UNITED STATES PATENT AND TRADEMARK OFFICE

APPLICATION NO.	FILING DATE	FIRST NAMED INVENTOR	ATTORNEY DOCKET NO.	CONFIRMATION NO.
10/783,339	02/20/2004	Brian Smidt	10646.399US01	6914
<div>7590 Merchant & Gould P.C. P.O. Box 2903 Minneapolis, MN 55402-0903</div>			<div>EXAMINER PAHNG, JASON Y</div>	
			<div>ART UNIT 3725</div>	<div>PAPER NUMBER</div>
			<div>MAIL DATE 05/17/2007</div>	<div>DELIVERY MODE PAPER</div>

Office Action Summary

DETAILED ACTION

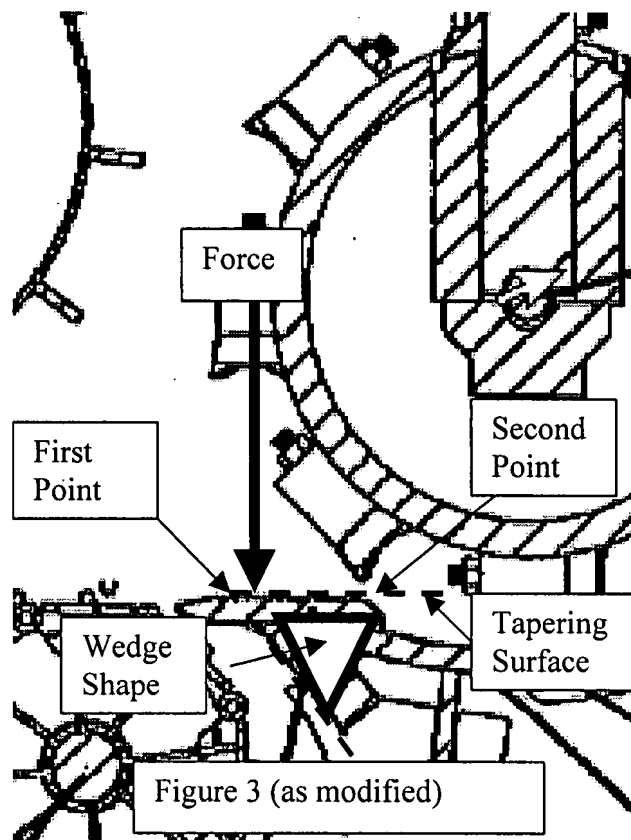
With regard to claim 12, Verhoef discloses a grinding machine with substantially all of the claimed structure including:

1. a grinding drum (160) positioned within a mill box (154) having opposite sides (155);
2. the grinding drum (160) having an axis of rotation (axis of 171);
3. an anvil (182) having a cross-section, the cross-section including a wedge-shaped portion and a rectangular portion (Figure 3);
4. the wedge-shaped (182) portion having a tapering surface extending from a first reference point (closest to 171) to a second reference point (farthest from 171);
5. the ends of the anvil (182) extending beyond (Figure 5a) the sides (155) of the mill box (154); and
6. the first and second reference points are horizontally aligned with one another.

With regard to claims 13, 28, 34, and 37, Verhoef discloses an anvil (182) of solid construction (Figure 3) without weakening structure. The top tapering surface of the wedge portion is oriented perpendicular to vertical impact perpendicular forces generated by the grinding drum as shown above in Figure 3 (as modified). In fact, Verhoef's discloses generated force as shown in Applicant's Figure 3.

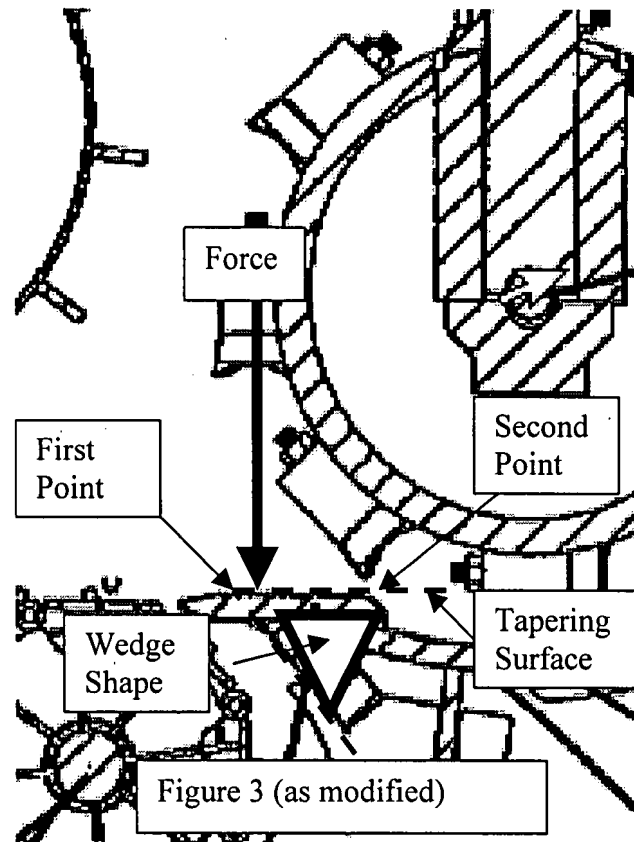
With regard to claims 12, 13, 15-17, 28, 31-35, and 37, Applicant argues that Verhoef does not disclose a horizontal tapering surface. This is not persuasive.

Verhoef discloses a horizontal tapering surface as shown below in a modified Figure 3.

With regard to claims 12, 13, 15-17, 28, 31-35, and 37, Applicant also argues that Verhoef does not disclose an anvil including a wedge shaped portion. This is also not persuasive. Verhoef discloses an anvil including a wedge shaped portion as shown above in a modified Figure 3. Also, it is pointed out that Applicant does not disclose an exact wedge shaped portion. See Applicant's Figure 9. Applicant merely discloses a portion similar to a wedge-shaped portion.
